#### Working Party on Brakes and Running Gear

#### Tyres – Regulation No. 54

## **Proposal for amendment to Regulation No. 54 (Tyres for commercial vehicles and their trailers)**

### **Submitted by the experts from the European Tyre and Rim Technical Organisation\***

Annex 3, replace:

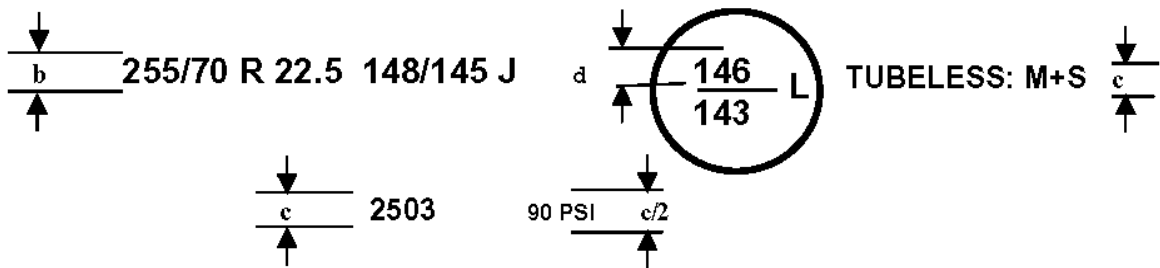
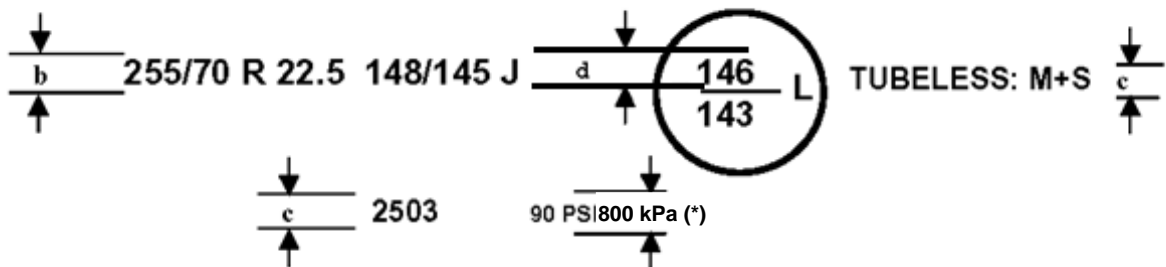
"3.1.10. An indication, by the "PSI" index, of the inflation pressure to be adopted for the load/speed endurance tests, as explained in Annex 7, Appendix 2. However, this indication, which it is permissible to restrict to one sidewall, shall not be mandatory, on any tyre submitted for approval, until two years after the date of entry into force of this Regulation. **In the case of tyres first approved after 1 November 2016, the inflation pressure to be adopted for the load/speed endurance tests, as explained in Annex 7, Appendix 2 shall be indicated in kilopascals, replacing the "PSI" index.**"

(\*)PSI marking instead of kPa may be used for tyres first type approved before 1 November 2016. "

1. It is proposed to replace the PSI Index by indicating the inflation pressure in kilopascals ("kPa"). By this, it will become possible to mark the same pressure as in all major tyre standards and avoid confusion in case of tyres marked according to UN Regulation N°. 54 and, at the same time, according to FMVSS 119 or FMVSS 139. The date of 1 November 2016 for the entry into force of this amendment is proposed for alignment in time with the introduction of Rolling Resistance, stage 2 and new Wet Grip requirements in UN Regulation No. 117.02.
